UNITED STATES PATENT AND TRADEMARK OFFICE

APPLICATION NO.	FILING DATE	FIRST NAMED INVENTOR	ATTORNEY DOCKET NO.	CONFIRMATION NO.
10/057,509	01/25/2002	Tatsuya Hirano	4304	4330
21553	7590	05/19/2004		
FASSE PATENT ATTORNEYS, P.A. P.O. BOX 726 HAMPDEN, ME 04444-0726				
EXAMINER MERCADO, JULIAN A				
ART UNIT			PAPER NUMBER	
1745

Office Action Summary

DETAILED ACTION

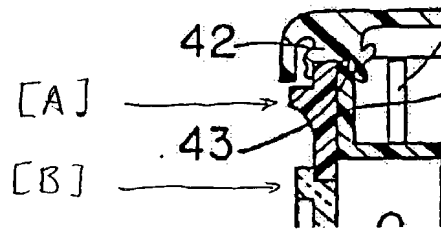
Regarding independent claim 1, EP ‘670 is relied upon to teach a battery having a thinner see-through window [6] portion provided on a sidewall of the battery casing. A reinforcing rib is

provided at said see-through window, such as the oval frame of the window [6] as shown in Figures 4 and 5. Figure 5 shows that the thickness of the battery casing [A] is equal to the thickness of the reinforcing rib [B]. (applies to dependent claim 4)

By this illustration it is considered that the reinforcing rib is a thicker portion of the see-through window. (applies to dependent claim 5) A plurality of reinforcing ribs such as partition walls [34, 35] and extending parallel to the height of the battery are provided at regular intervals for dividing the battery into a plurality of cells. (col. 9 line 25-52, applies to dependent claims 2 and 3) As to positioning the reinforcing rib "in alignment with said partition" (dependent claim 2), the ribs in EP '670 are considered to be in "parallel" alignment. The window is provided on one side surface of a rectangular-shaped battery. (applies to dependent claim 6)
